SAN ANSELMO FLOOD RISK REDUCTION PROJECT

Final Environmental Impact Report
Volume 2 - Response to Comments
State Clearinghouse No. 2017042041

Prepared for
Marin County Flood Control and Water
Conservation District

Figure 3-3
Ross Valley Flood Protection and Watershed Program

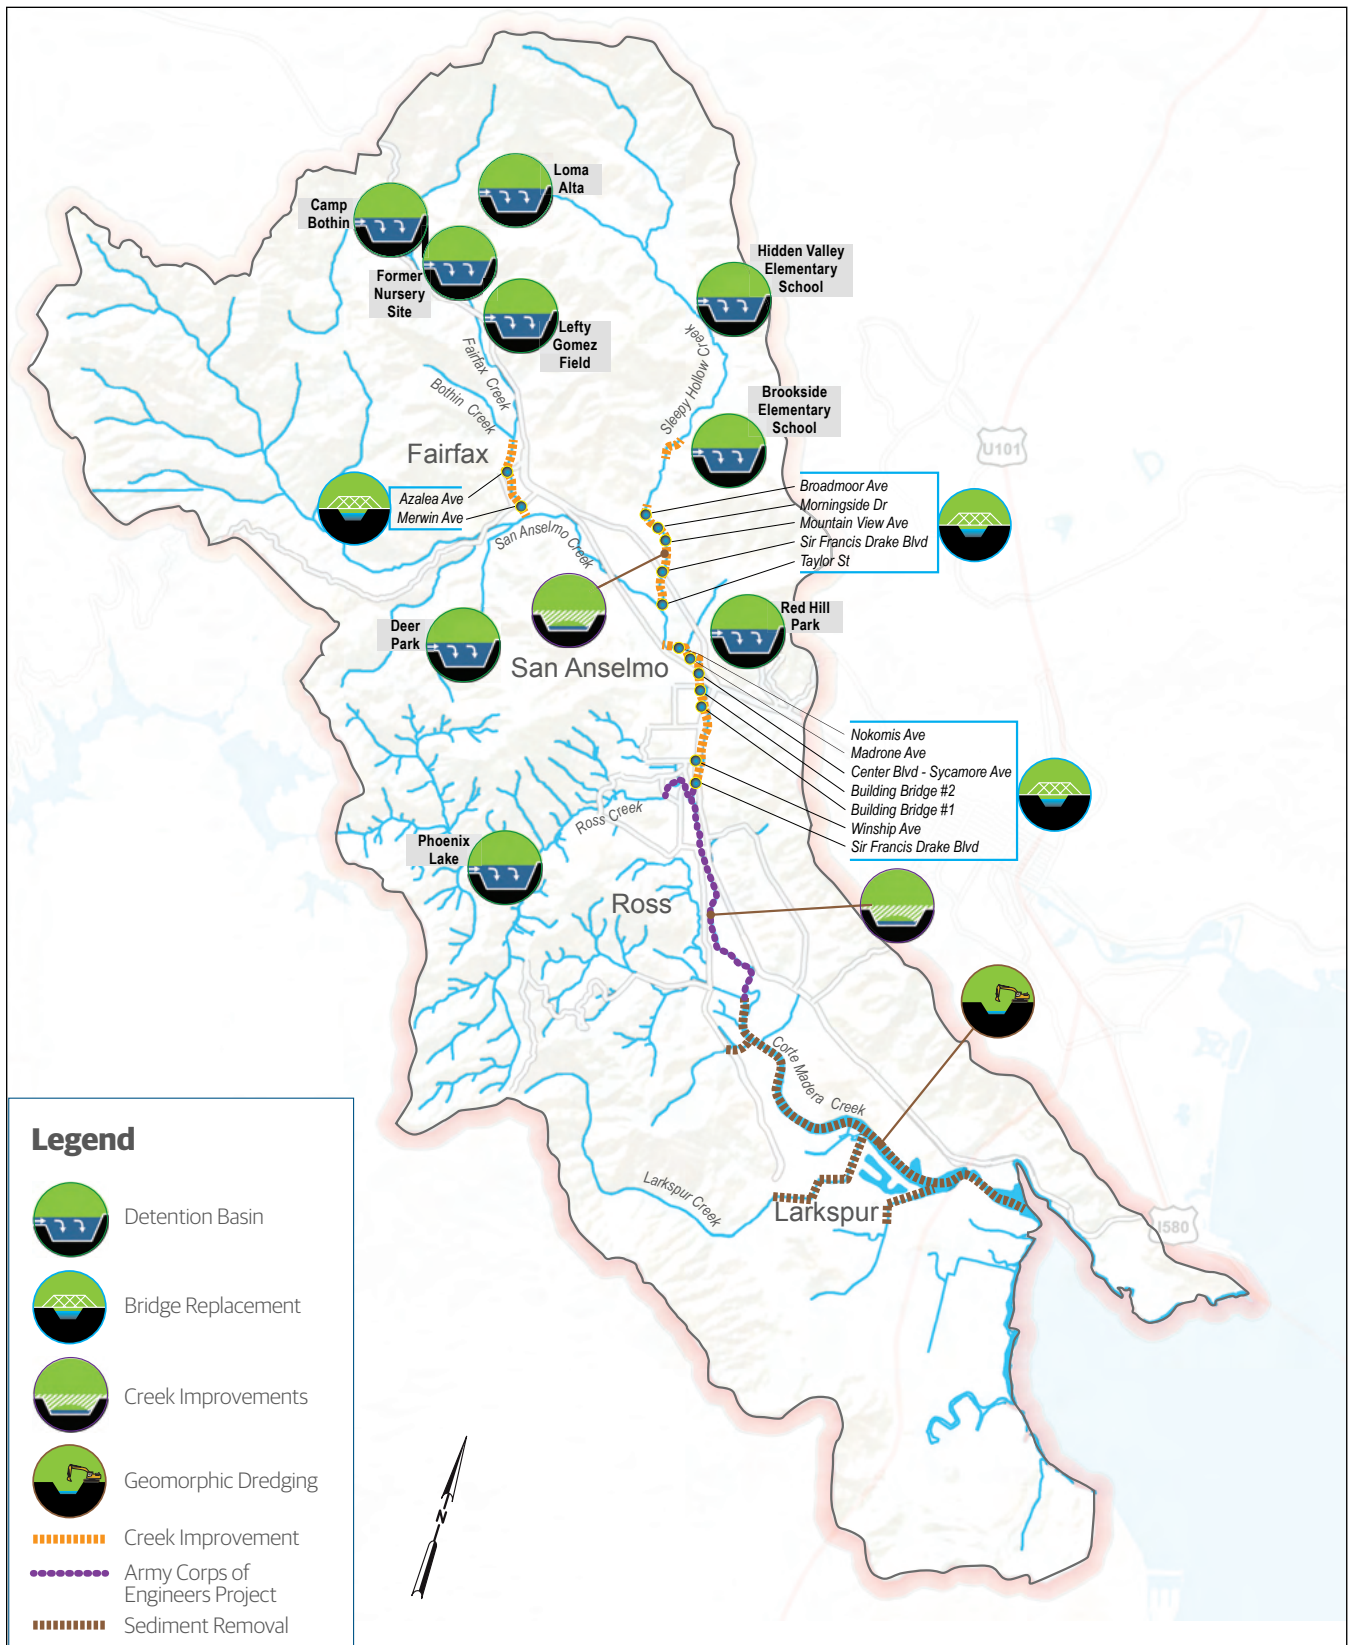
C4-1 This comment says that the map illustrating elements of the Ross Valley Flood Protection and Watershed Program (Figure 3-3) and text describing some of those elements should be revised to exclude Memorial Park, Lefty Gomez, Deer Park, and all other sites on land designated for education.

These comments relate to the Ross Valley Program currently under development. Few specific decisions have been made as to what elements would eventually be constructed as part of the Ross Valley Program. As suggested in this comment, an updated map of the Ross Valley Program has been inserted in place of the previous version of Figure 3-3 in the Final EIR. The revisions to this figure do not result in any changes to the environmental analysis included in the Draft EIR.

In response to Comment C4-1, Draft EIR Figure 3-3 (page 3-5) has been revised, as shown on the following page.

Figure 3-13a
Water Surface Elevation Change With Project
10 - Year Flood Event: Fairfax Area

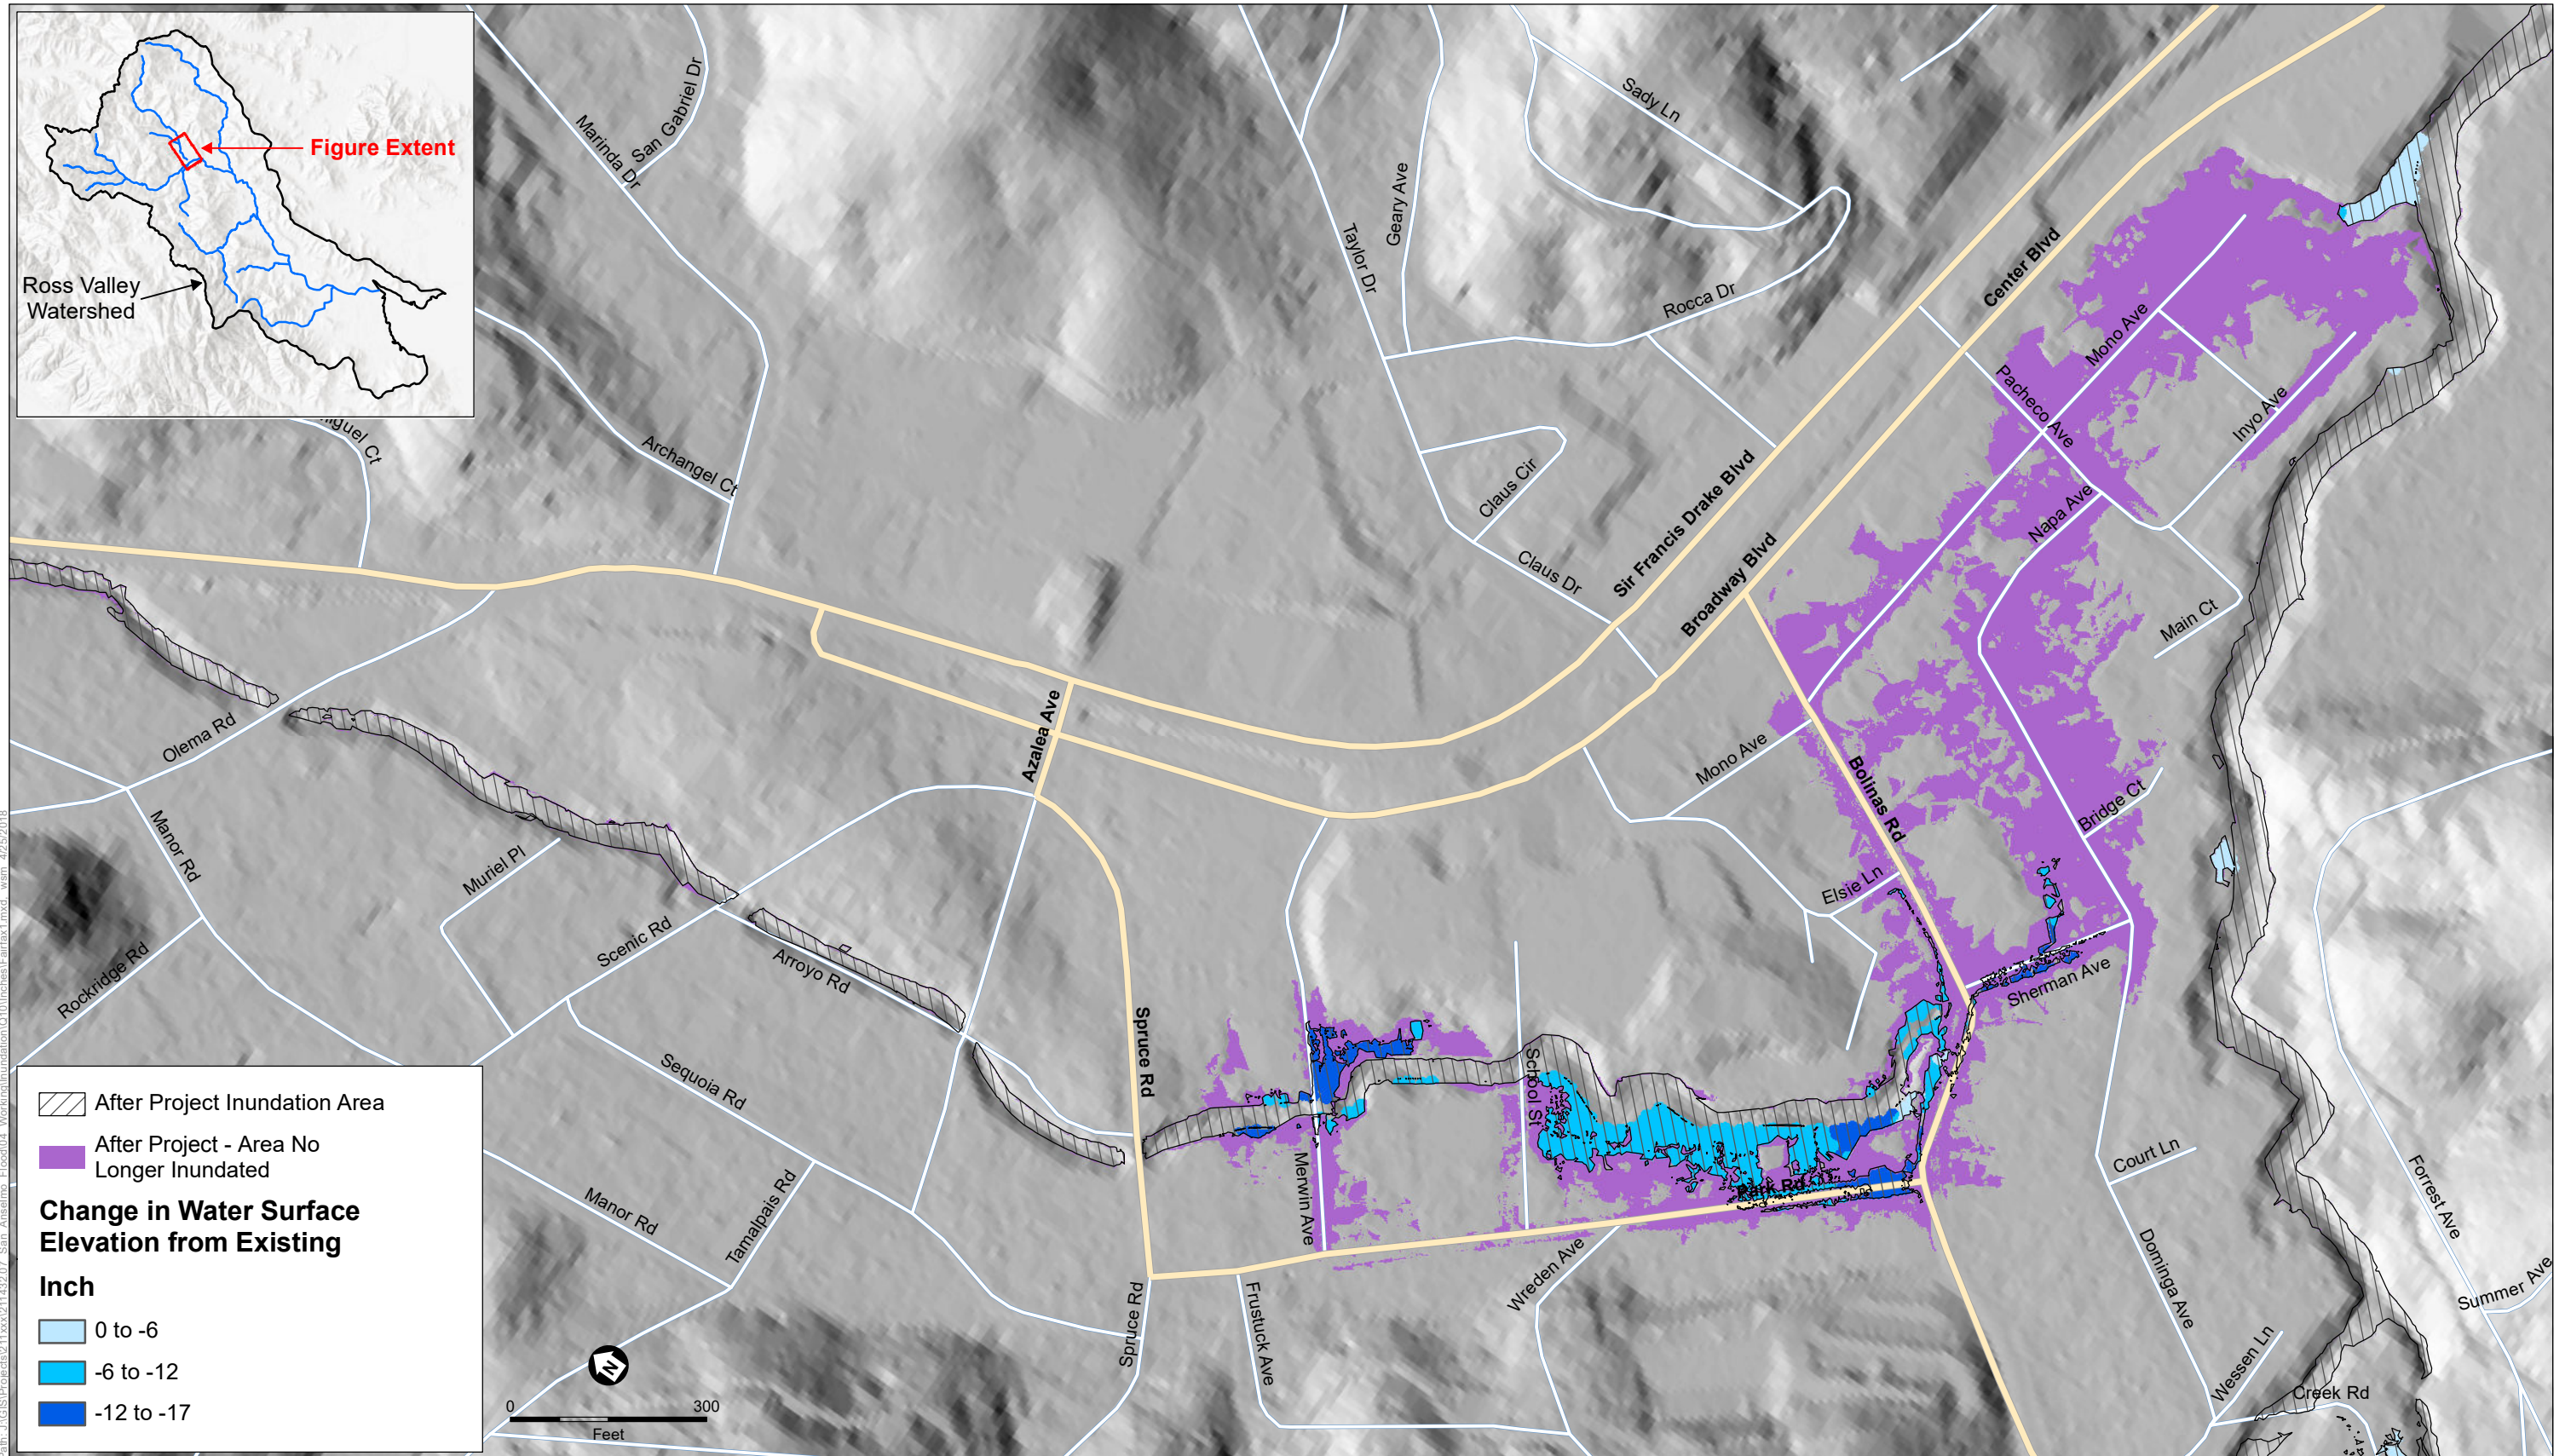
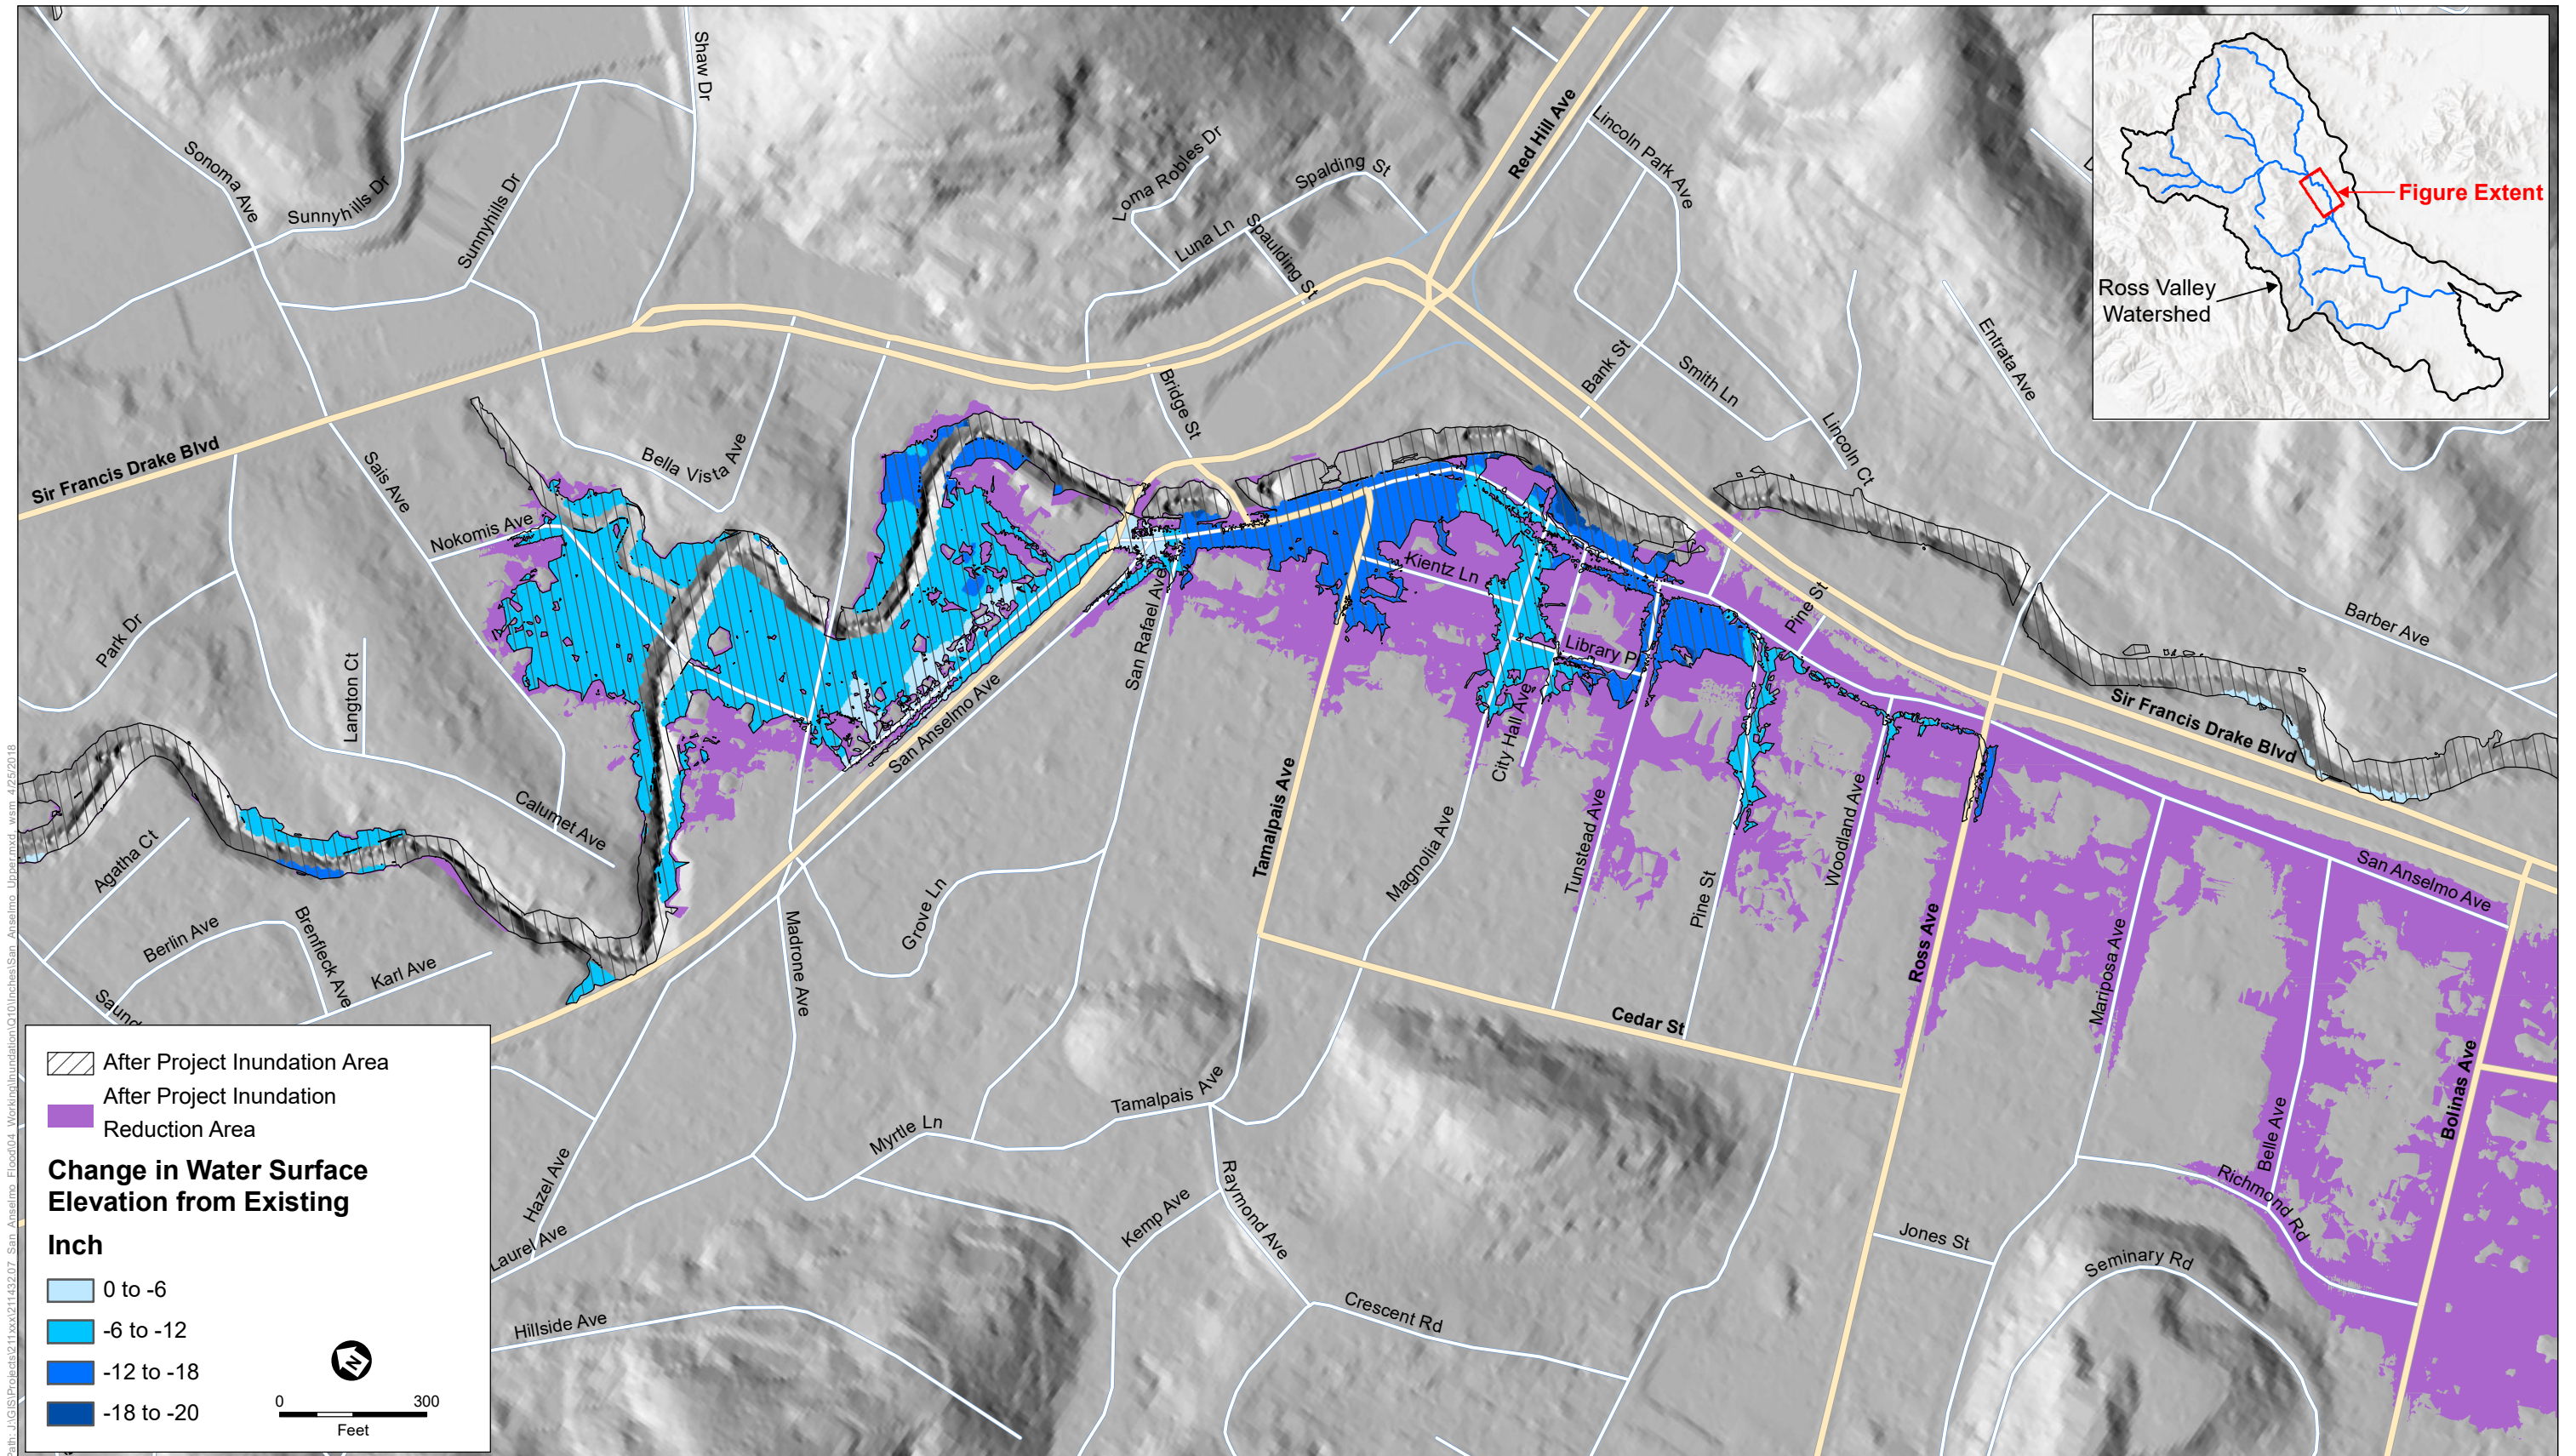
Figures in Chapter 3 (figures 3-13, 3-14, and 3-15), that show water surface elevation, change with project are not easy to interpret. It appears that the purple areas, labeled "After Project Inundation Reduction Area" would be removed from flooded areas during the specified events. However, use of the word "reduction" suggests that they would still be inundated, just to a lesser extent.

Draft EIR Figures 3-13a-c, 3-14a-c, and 3-15a-c have been revised in response to this comment. The revisions to these figures do not result in any changes to the environmental analysis in the Draft EIR.

In response to Comments B1-5 and PH-2, the legend descriptions associated with purple areas of Draft EIR Figures 3-13a-c, 3-14a-c, and 3-15a-c (Draft EIR pages 3-25 through 3-33) have been revised to read:

After Project ~~Inundation Reduction Area~~ – Area No Longer Inundated
